SUPPLEMENT NO. 1

PHILIP R SMITH ELEMENTARY SCHOOL
GILBANE JOB NO. J07896.000
STATE PROJECT NO. 132-0089N

PRS-SI-0007

Owner Room Names and Signage

TITLE
OWNER ROOM NAMES AND NUMBERS, AND IDENTIFICATION SIGNAGE PLAN

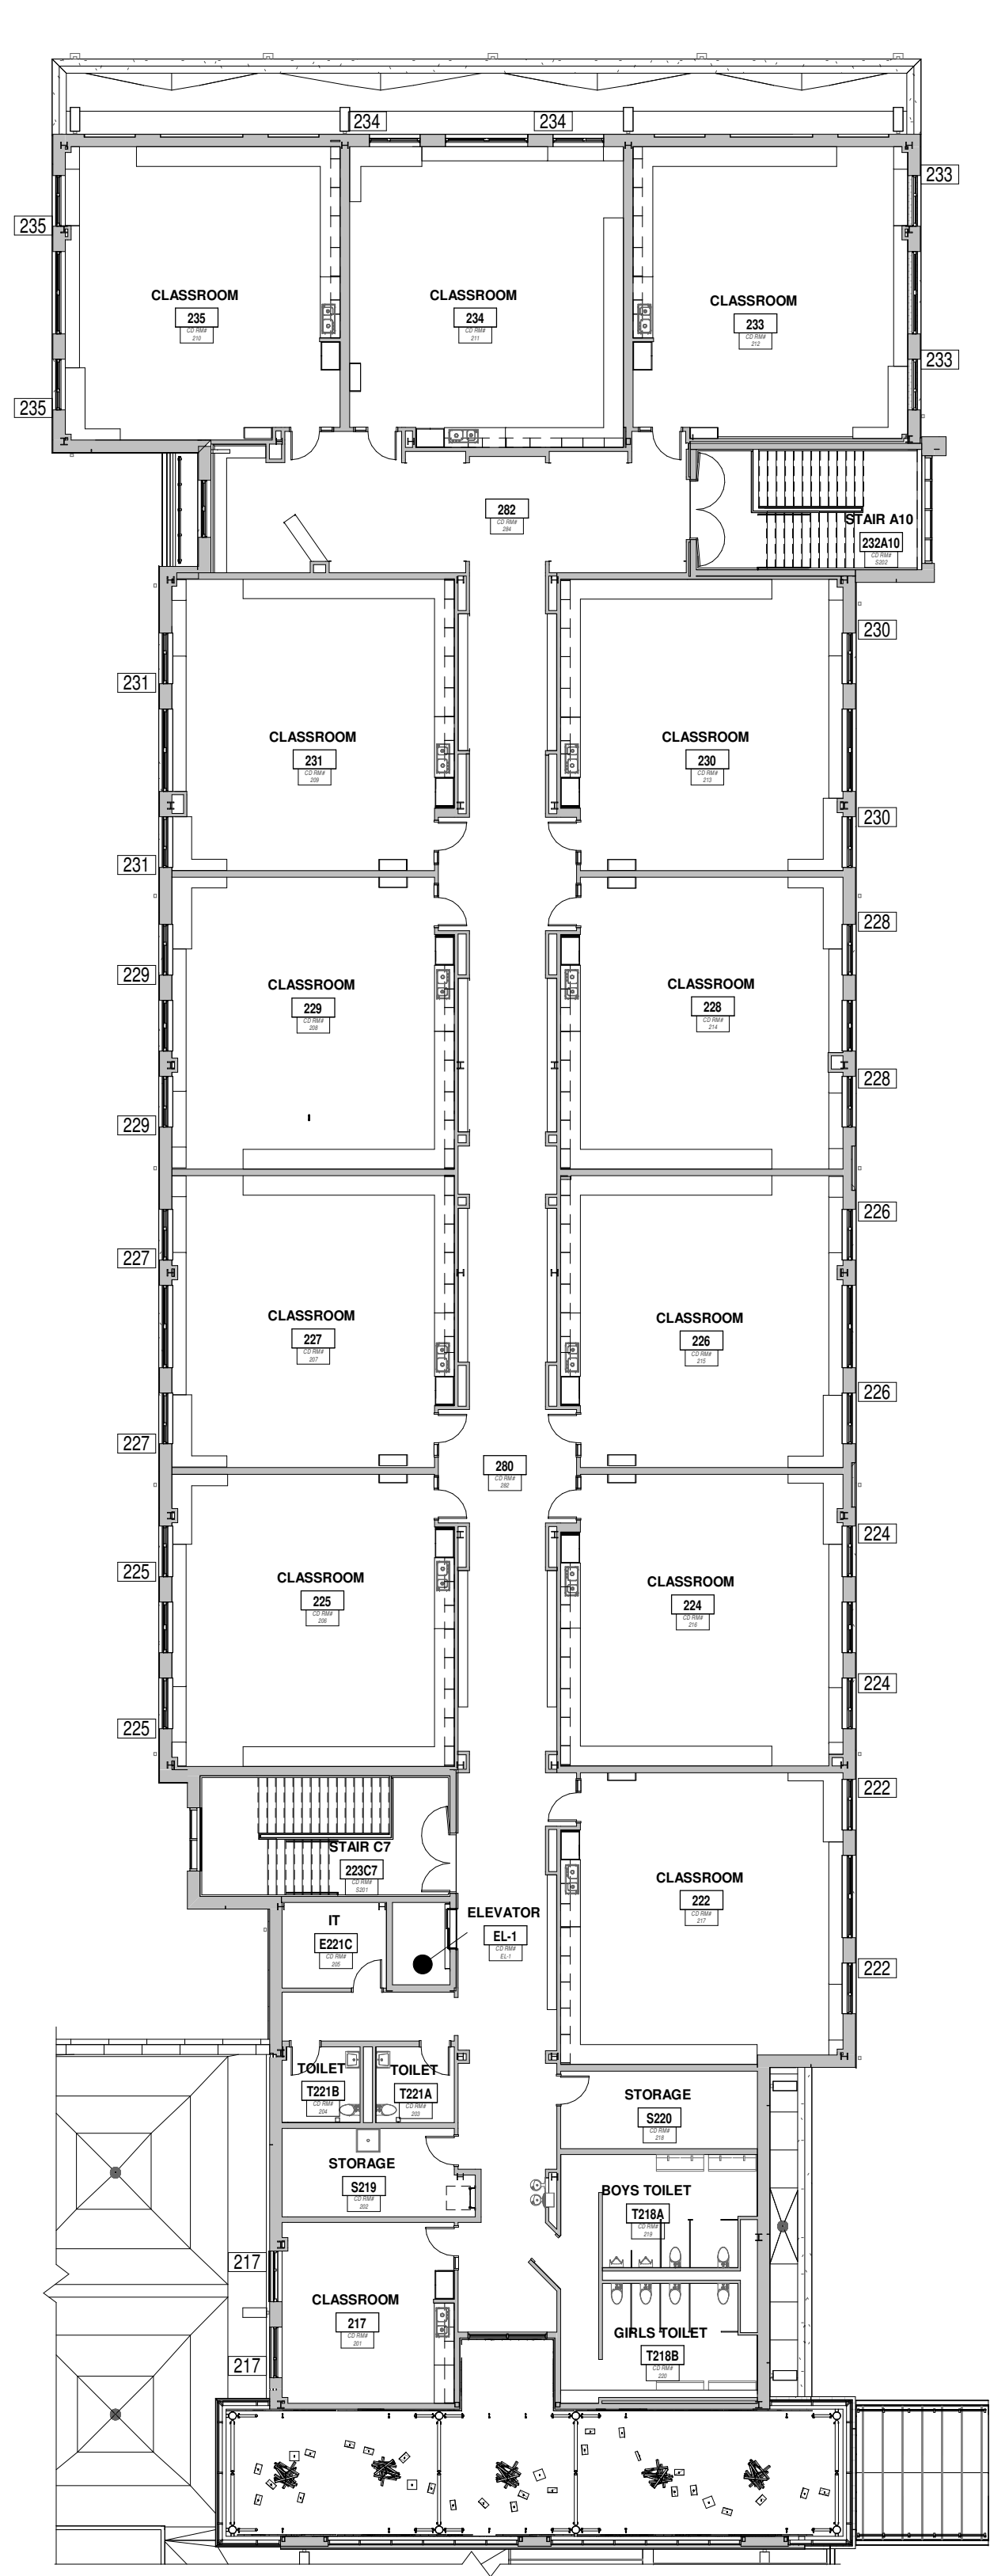
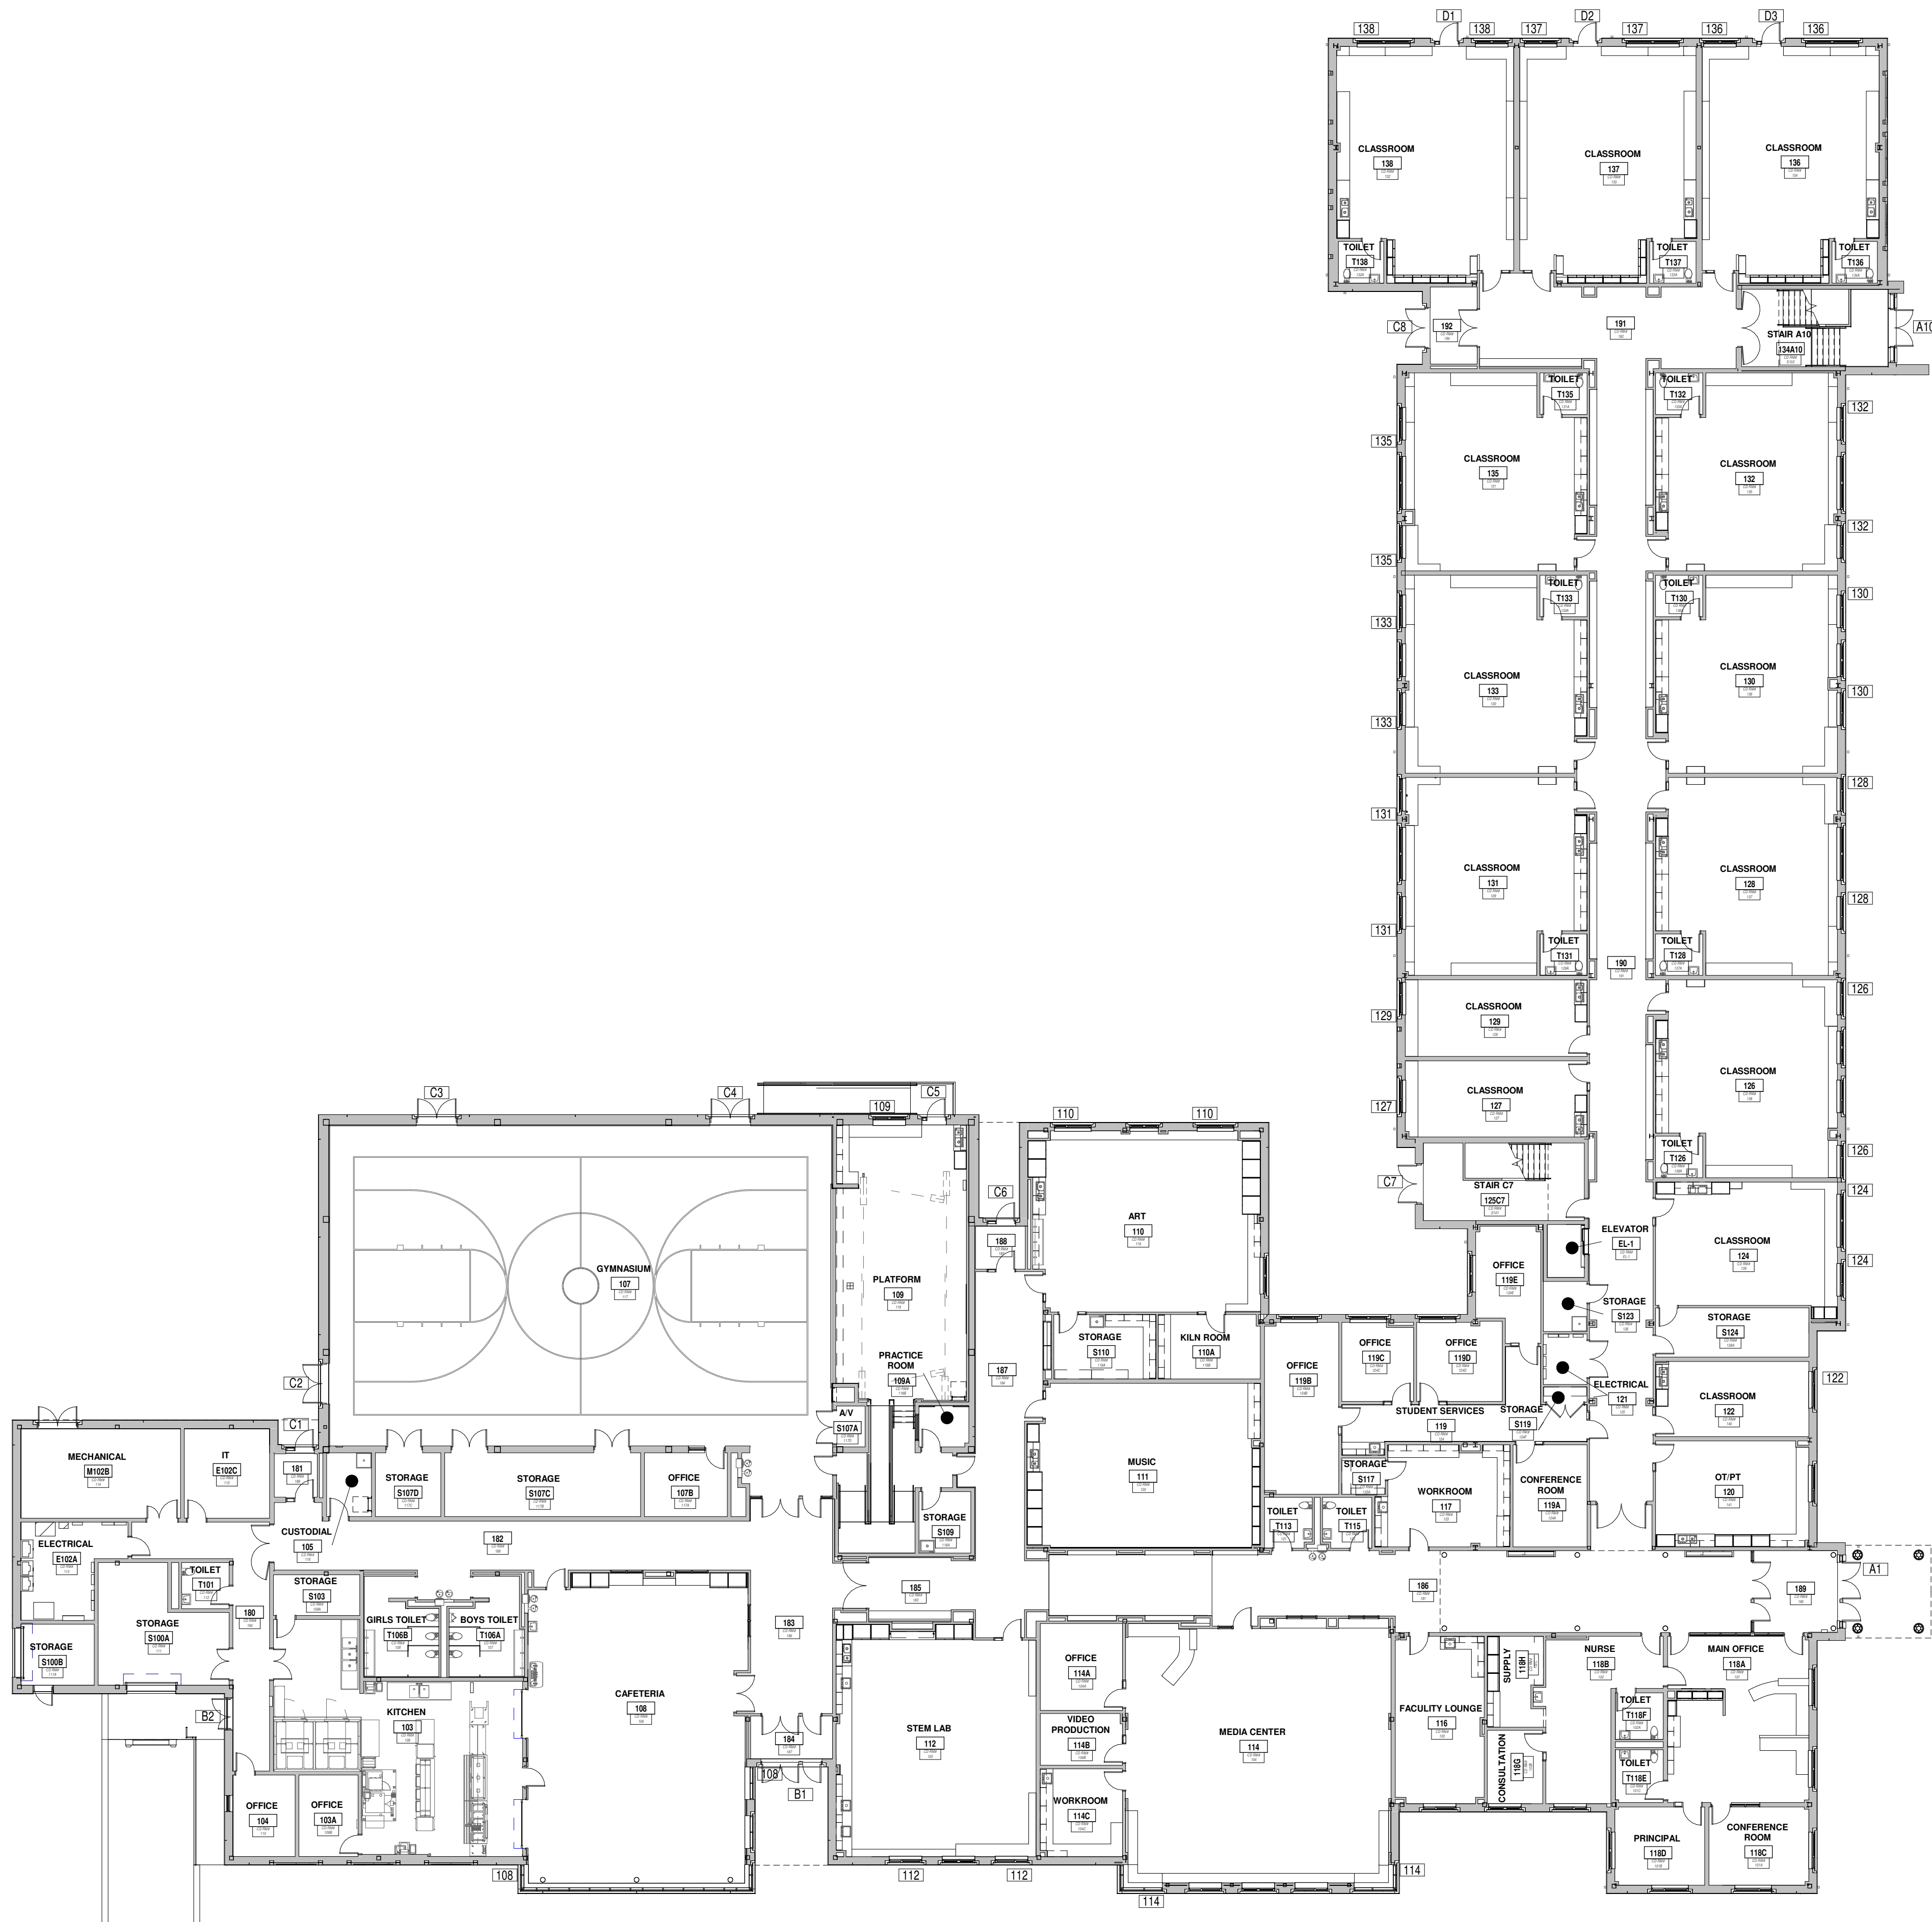
This Supplemental Instruction, PRS-SI-007, updates the room names and numbers to the final designations per the owner's review. The SI also revises and deletes sign types as noted below.

- **REVISE** room names and numbers per Owner's review
- **REVISE** letter and character thickness from 1/4" to 1/32" at Signage Types B, C, D, E, F, and G
- **DELETE** Type A sign from the following rooms:
 - 183, 193, 281, 285,
- **REVISE** Type D sign to Type A sign in the following rooms:
 - 109B, 110, 117 117A,
- **REVISE** Type A sign to Type D sign in the following rooms:
 - 119B, 124
